Development Permit Panel

Wednesday, April 30, 2014 3:30 p.m.

Re: Application by MQN Architects for a Development Permit at 9140 and part of

Richmond Mitsubishi Motors - Design Rationale - Revised

drawing title: LANDSCAPE PLAN

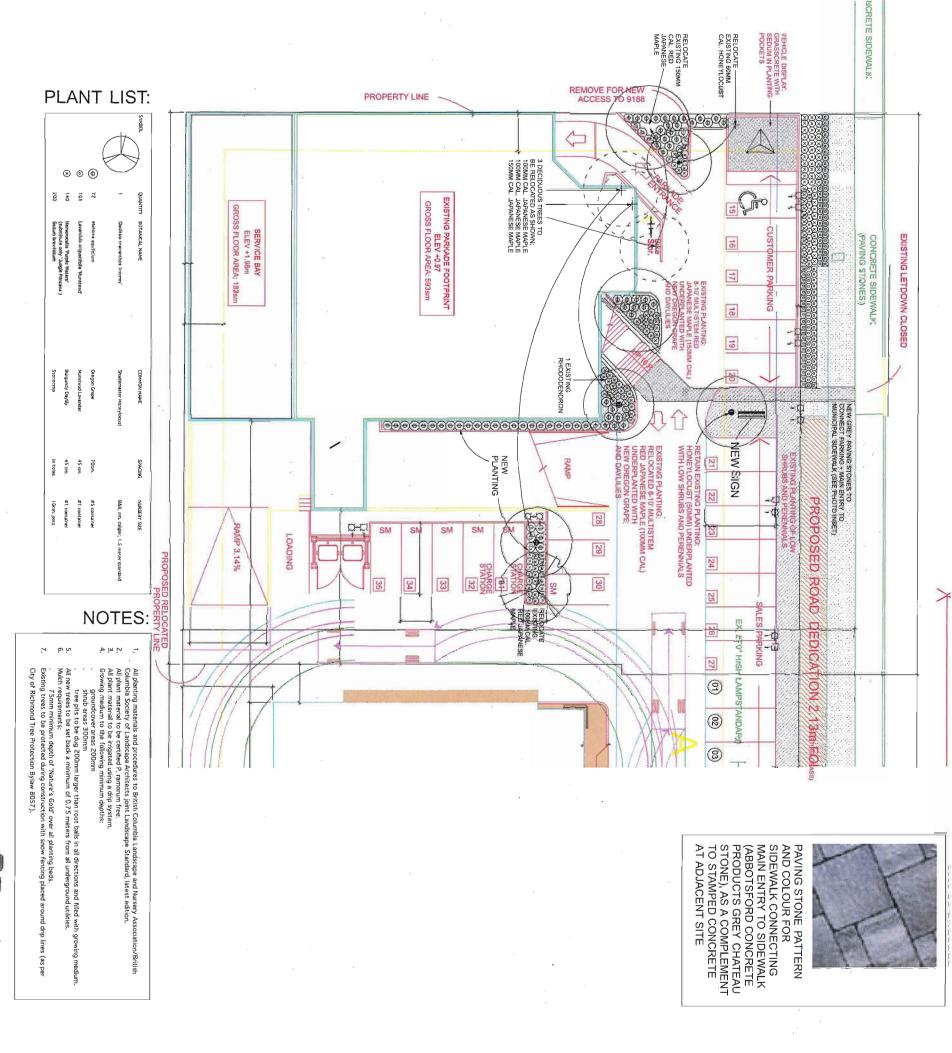
landscape is modest and simple; consider expanding and consolidating the planting across the subject development and the adjacent development to the east to unify the streetscape and minimize on costs;

• consider a solid but removable temporary landscape treatment to the western edge of the parking lot to provide future access to the site to the west if needed;

MQN: a new landscape plan has been included in the revised package dated 02/07/13- Re-issued for Development Permit. This plan shows that the landscaping on the boulevard will have the same landscaping vocabulary as the 9200 Bridgeport site.

MQN: a new landscape plan has been included in the revised package dated 02/07/13- Re-issued for Development Permit. This plan shows that the landscaping on the north west corner adjacent the car display area will remain landscaped until such a time where the frontage road is extended to the adjacent property.
